May 31, 2002
L-02-065

Subject: Beaver Valley Power Station, Unit No. 1
Docket No. 50-334, License No. DPR-66
License Amendment Request No. 301
Positive Moderator Temperature Coefficient

Subject: Application for Amendment to the Technical Specification listed in Section 2 to implement a Positive Moderator Temperature Coefficient at Beaver Valley Power Station, Unit No. 1.

Figure 3.1-1
 Moderator Temperature Coefficient versus Power Level

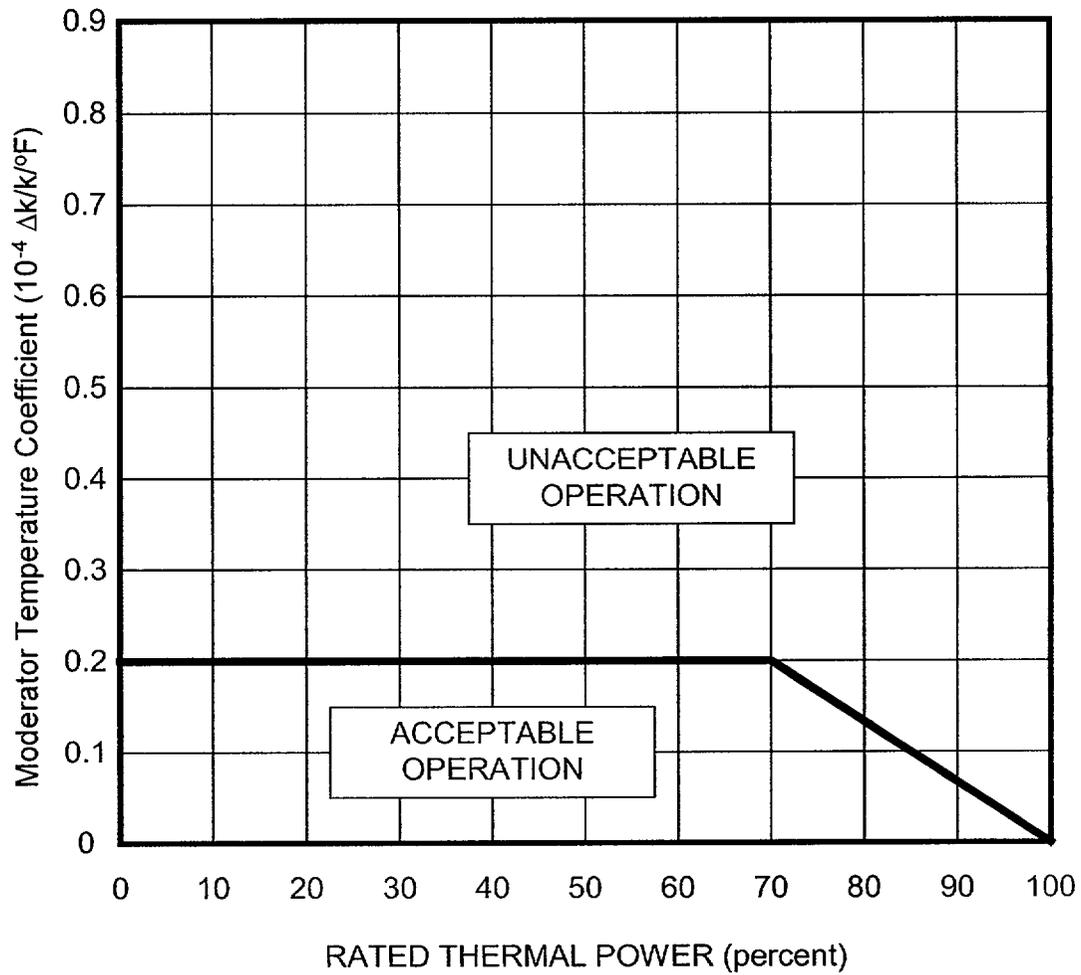
- a. ~~Less positive than $0 \times 10^{-4} \Delta k/k/^{\circ}F$, ← INSERT 1~~
- b. Less negative than $-5.0 \times 10^{-4} \Delta k/k/^{\circ}F$ at RATED THERMAL POWER.

Less positive than $+0.2 \times 10^{-4} \Delta k/k/^{\circ}F$ for power levels up to 70% of RATED THERMAL POWER, with a linear ramp to $0.0 \times 10^{-4} \Delta k/k/^{\circ}F$ at 100% RATED THERMAL POWER as shown in Figure 3.1-1 and
